**A RESOLUTION BY THE EXECUTIVE BOARD
OF THE KNOXVILLE REGIONAL
TRANSPORTATION PLANNING ORGANIZATION (TPO)
AMENDING THE FY 2023-2026 TRANSPORTATION IMPROVEMENT PROGRAM**

Attachment #4D: Draft Amendment 23-2020-012 (Relocated Alcoa Hwy. [SR-115/US-129]) - Amend project to increase FY 2023 construction cost estimate to \$175,000,000. This amendment adds \$69,700,000 NHPP (\$55,760,000 federal/\$13,94,000 state) to the project and TIP. The total project cost is increased to \$187,800,000.

DRAFT 3-27-2023 for Public Review**Short Conformity Report for
April 2023 Knoxville Regional TPO TIP Amendments****Project ID's:**

Relocated Alcoa Hwy. (SR-115/US-129)

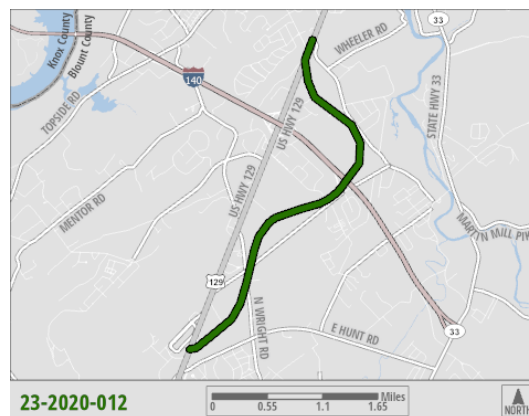
Amend project to increase FY 2023 construction cost estimate to \$175,000,000. This amendment adds \$69,700,000 NHPP (\$55,760,000 federal/\$13,940,000 state) to the project and TIP. The total project cost is increased to \$187,800,000. The construction cost increase partially reflects inflation factors as well as funds becoming available from other project delays across the state allowing for some stage 2 work to be incorporated into this stage.

Pellissippi Pkwy. (SR-162) Extension

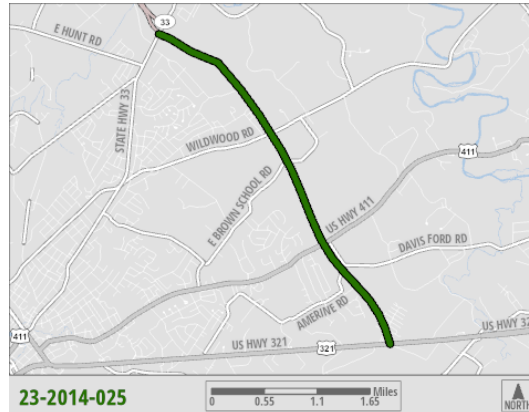
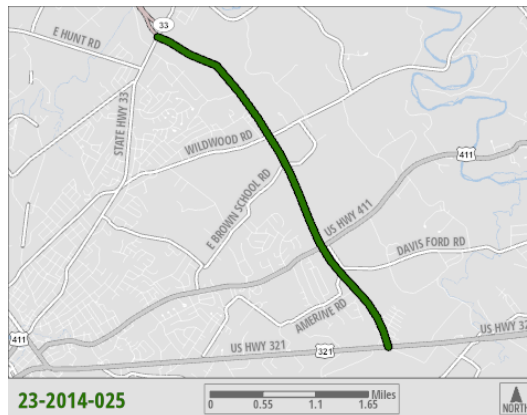
Amend project to revise the project descriptive elements, increase programmed Right of Way funding and total project cost. The project length is increased to 4.9 miles and the termini description is revised to "(Pellissippi Parkway) from "near" SR-33 to SR-73 (US-321) (IA)". ROW phase costs in FY 2023 are revised to include \$20,709,838 (\$16,567,870 federal NHPP/\$4,141,968 state). This amendment adds \$20,709,838 (\$16,567,870 federal NHPP/\$4,141,968 state) to the project and the TIP. The total project cost is increased to a corrected \$184,200,000.

Foothills Mall Dr. Extension Ph. 2

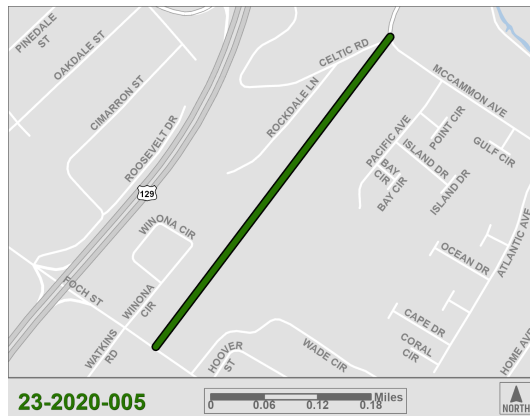
3. TIP Project #23-2020-005 / KRMP ID# 10-260 – Foothills Mall Dr. Extension Ph. 2. The project limits and map on the TIP page are being updated to match the overall envisioned project that was included and modeled for the Mobility Plan 2045. The TIP map did not show the portion on existing alignment of McCammon Ave that carries the project to a logical terminus point where a previous intersection improvement of McCammon Ave at Bessemer St provided a curb & gutter section with sidewalk up to a shopping center driveway. The portion on new alignment between Foch St and McCammon Ave is the critical portion that causes this to be an air quality conformity non-exempt project and that is unaffected by this amendment in terms of how it has been modeled for conformity in the TPO travel demand model.

\$80,000 federal L-STBG previously obligated
Amend project to revise the project termini, description and length. Project termini are revised from "Foch St. to McCammon Ave." to "Foch St. to near Bessemer St.". The project length is increased to 0.76 miles and the project description is revised to "Construct new 2-lane road with turn lanes where needed from Foch St. to McCammon Ave., at Celtic Rd. and Reconstruct McCammon Ave. to an improved 2-lane roadway with curb & gutter to tie in with previous improvements near the Bessemer St. intersection. Project includes a multi-use path on one side throughout". No funding changes are included with this amendment and the total project cost is unchanged.
